**KITCHEN MACHINES**  
**Except Prospero & kMix Series**  
**STAINLESS STEEL WHISKS****Date: 19.11.2019**Introduction:

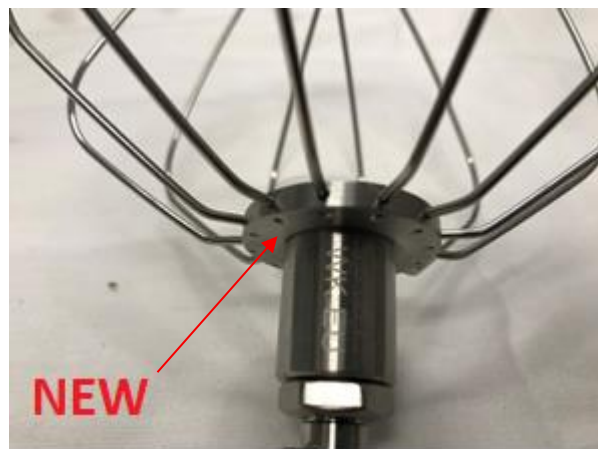
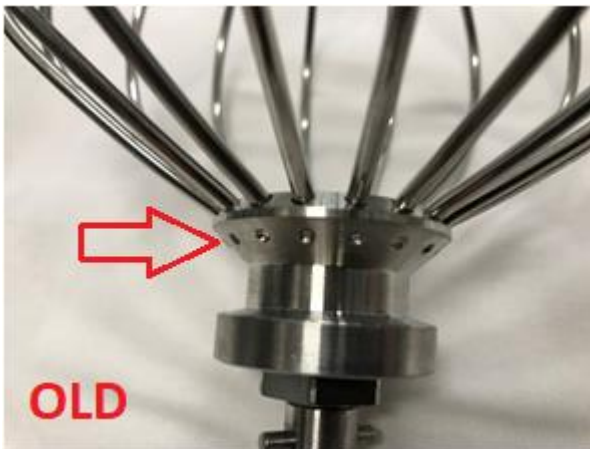
The diameter of the Stainless-Steel Whisk wire and the number of wires have been reduced, which consequently increases the gap between the wires to improve whisking performances.

The wire holes are drilled perpendicular to the shaft as opposed to the old whisk wires which are drilled at an inclined angle (see below pictures).
